South Texas Project Electric Generating Station 4000 Avenue F - Suite A Bay City, Texas 77414

August 12, 2008  
ABR-AE-08000061

South Texas Project  
Units 3 and 4  
Docket Nos. 52-012 and 52-013  
Response to Requests for Additional Information

Attached are responses to NRC staff questions included in Request for Additional Information (RAI) letter numbers 31, 34, 39, 40, 49, 50 and 52 related to Combined License Application (COLA) Part 2, Tier 2 Sections 2.4S and 2.5S. This submittal includes responses to the following Question numbers:

No COLA revision is required as a result of this RAI response.

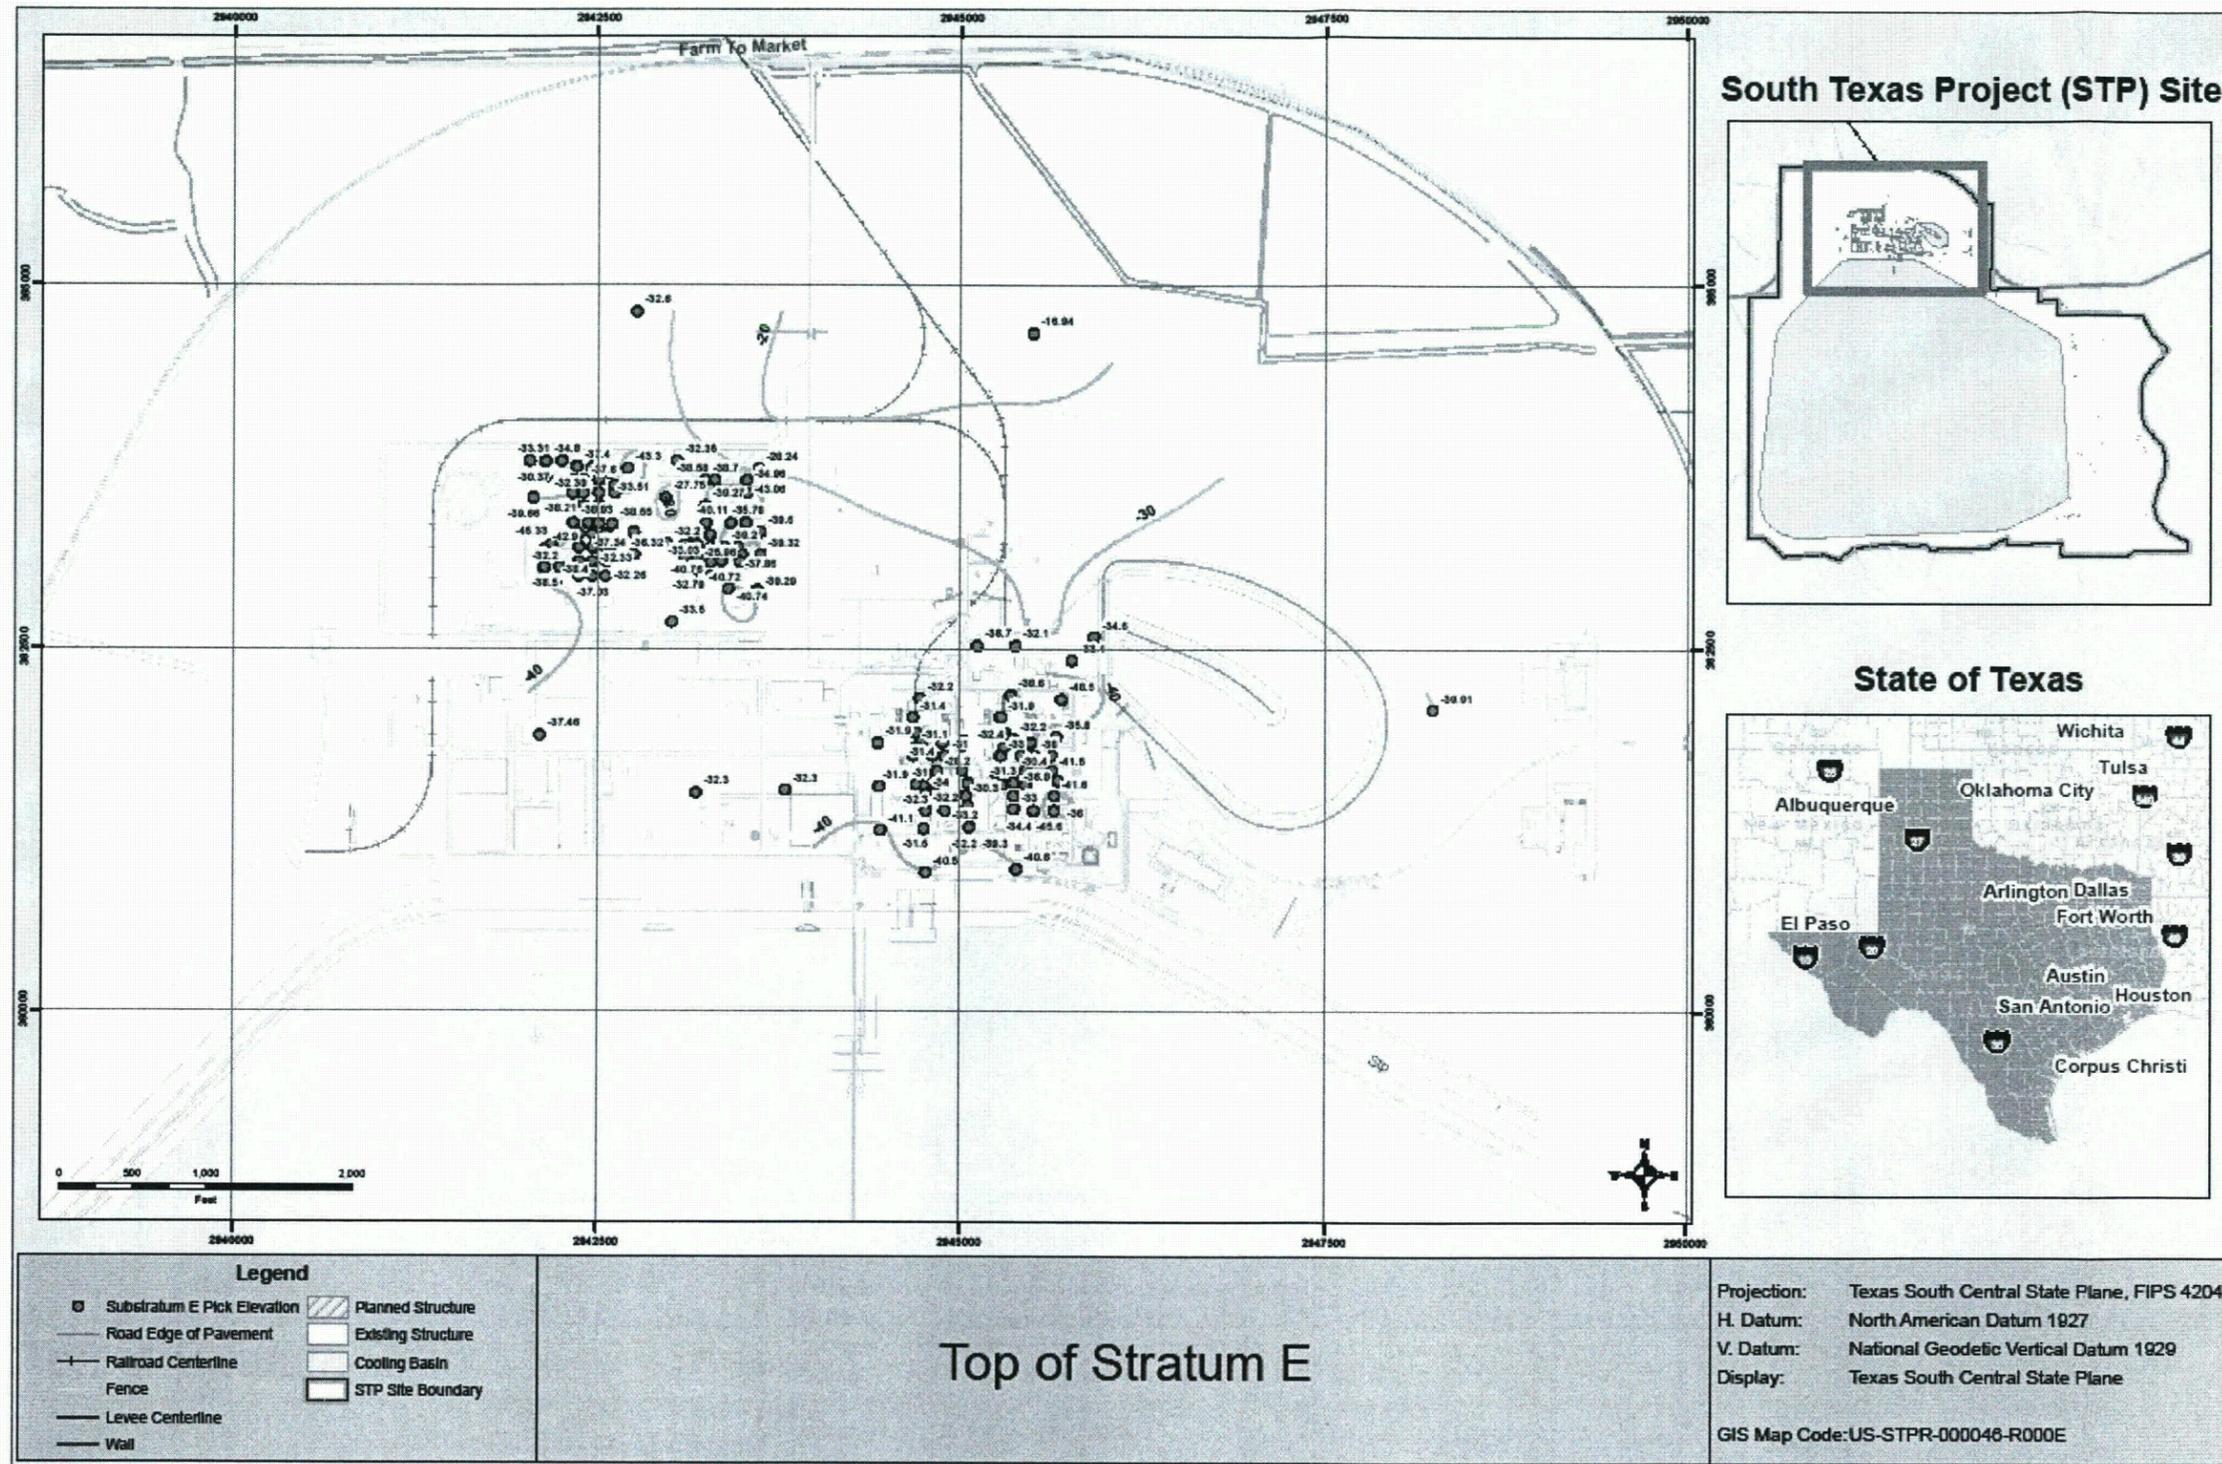
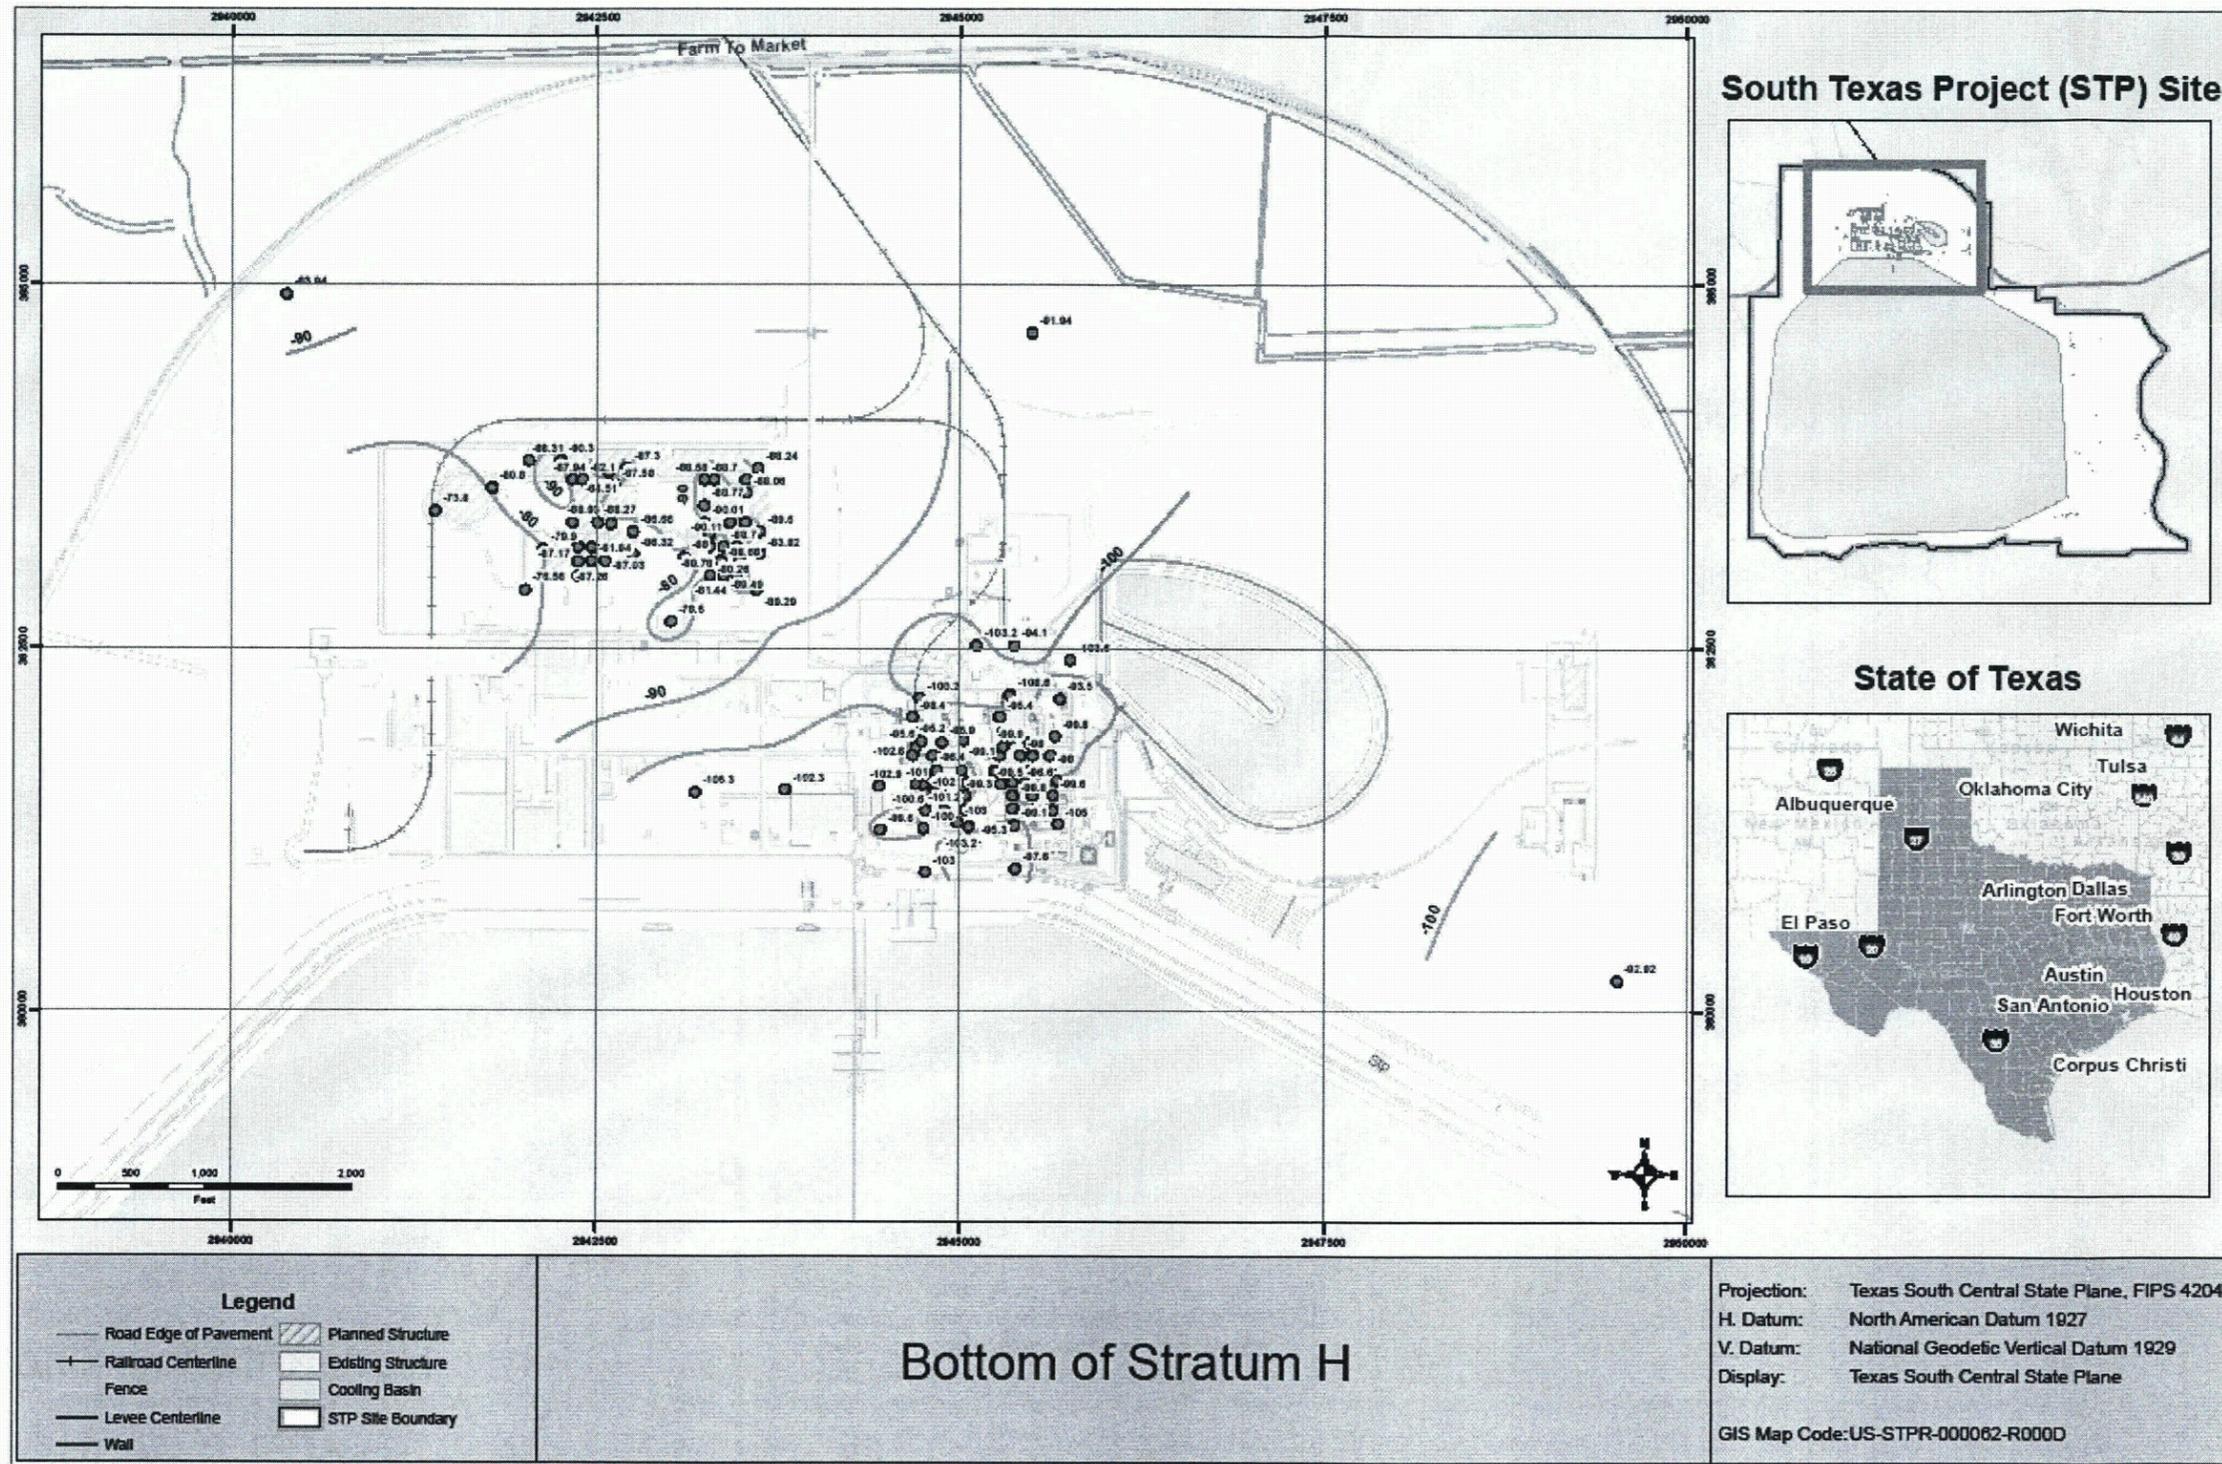
Provide detailed surface maps for top and bottom elevations of both Upper and Lower Shallow Aquifers as they are needed to better understand and predict on-site groundwater flow and pathways. Figure 2.4S.12-10 shows many piezometric wells around Units 1 and 2, but it is not clear whether the water level data from all the wells were used for the water level contour maps in Figure 2.4S.12-19. Please clarify.

The requested maps are attached. The maps are a geostatistical interpretation of available data representing the top and bottom elevations of the Upper Shallow Aquifer (Geotechnical Stratum C from FSAR 2.5S.4) and Lower Shallow Aquifer (Geotechnical Strata E and H from FSAR 2.5S.4). The tension-spline method in ESRI ArcGIS software was used to contour the available data. The data are from the Units 1 & 2 UFSAR (reference) and the STP Units 3 & 4 geotechnical evaluation.

The Lower Shallow Aquifer includes two sand units (Geotechnical Strata E and H) separated in places by a discontinuous clay unit (Geotechnical Stratum F from FSAR 2.5S.4). Where encountered in borings, this clay unit has been observed with a thickness that can range from about 0.7 feet to about 61.5 feet with an average of about 20 feet. However, the encountered thickness at most borings is between about 10 to 30 feet. (It should be noted several borings did not fully penetrate the unit.)

The water level contour maps in Figure 2.4S.12-19 used the data from the observation wells drilled during the 2006 - 2007 subsurface investigation for Units 3 & 4 (the "Units 3 & 4 wells"), because this was the only relevant data available for the two dates represented in that figure. The other piezometers shown in Figure 2.4S.12-10 were installed more than 20 years ago. Most of these piezometers no longer exist or relevant construction details are no longer available. The most recent data available from these piezometers are from May 1, 2006. The earliest data available for the "Units 3 & 4 wells" are from December 28, 2006 (Table 2.4S.12-7). These two data sets are not contemporaneous and, as a result, cannot be combined to prepare contour maps such as those in Figure 2.4S.12-19. Plans are underway to install additional observation wells at the STP site to obtain hydrogeologic information in the vicinity of Kelly Lake and to reduce the uncertainty associated with the groundwater flow paths near the MCR and site boundary.

**Figure 2.4S.12 - XX**  
**Potentiometric Surface in the Upper Shallow Aquifer** 1, 2, 3

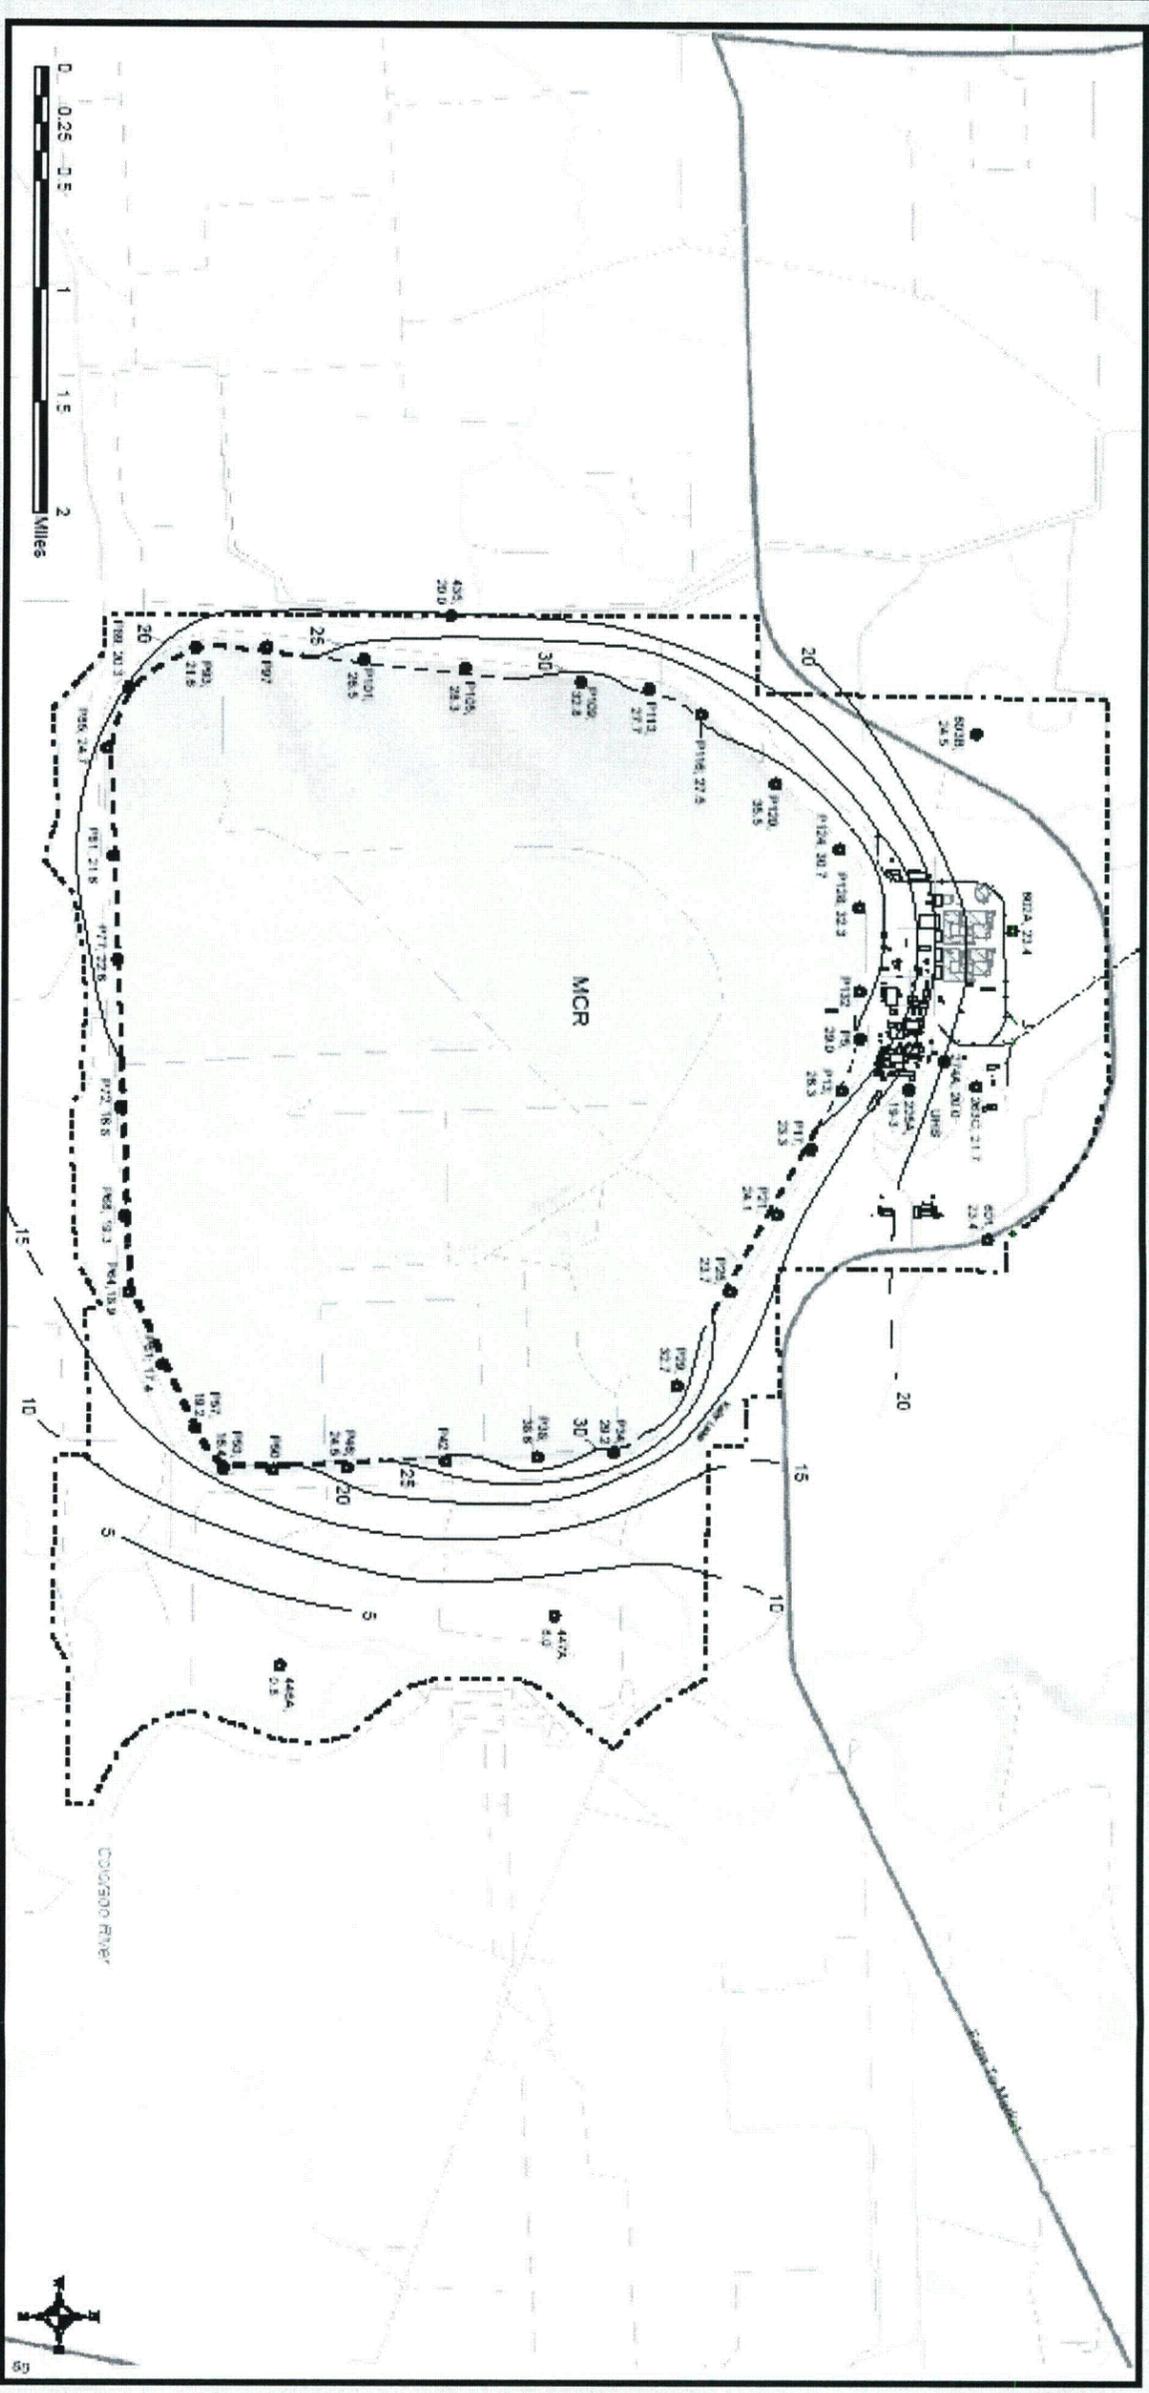
In FSAR Section 2.4S.13.1.2, Conceptual Model, the applicant closes with a four-point summary of the alternate pathways. This needs elaboration, for example, (a) Under item (1), were thermal phenomena and buoyancy of heated water considered when making the statement "... there is no mechanism to lift the liquid ..."? While data are not included, the waste waters may be at elevated temperature relative to the ambient groundwater setting, and buoyancy may be a factor to be considered. (b) Under item (2), it is not clear that the schematic diagram in FSAR Figure 2.4S.12-21 represents actual data. In which tables do the data appear? Please provide a realistic three dimensional analysis. Complete the potentiometric surfaces of the Upper Shallow Aquifer, i.e., show contours underlying the MCR. The potentiometric surfaces of the Lower Shallow Aquifer indicate groundwater flow toward and under the MCR rather than around it. Why would the Upper Shallow Aquifer not also present an under rather than around pathway? Explain the reasons why the pathways presented are the most plausible, by providing the basis for them. (c) Under item (4), the issue of under versus around appears again. In addition, was the concept of the paleochannel raised in FSAR Section 2.4S.12.2.4.1 incorporated into the rationale when discarding this pathway?

Figure 2.4S.12-XX (attached) is a contour map of water-level elevations listed in Table 2.4S.12-XX in piezometers in the Upper Shallow Aquifer at the "A" position in each set around the MCR embankment, and in other available piezometers throughout the site. This map shows the piezometric surface in the Upper Shallow Aquifer beneath and in the vicinity of the MCR, and indicates that groundwater flow is outward from the MCR along the entire length of the embankment.

Figure 2.4S.12-XX is a contour map of water-level elevations in piezometers in the Upper Shallow Aquifer at the "A" position in each set around the MCR embankment, and in other available piezometers throughout the site. This map shows the piezometric surface in the Upper Shallow Aquifer beneath and in the vicinity of the MCR, and indicates that groundwater flow is outward from the MCR along the entire length of the embankment.
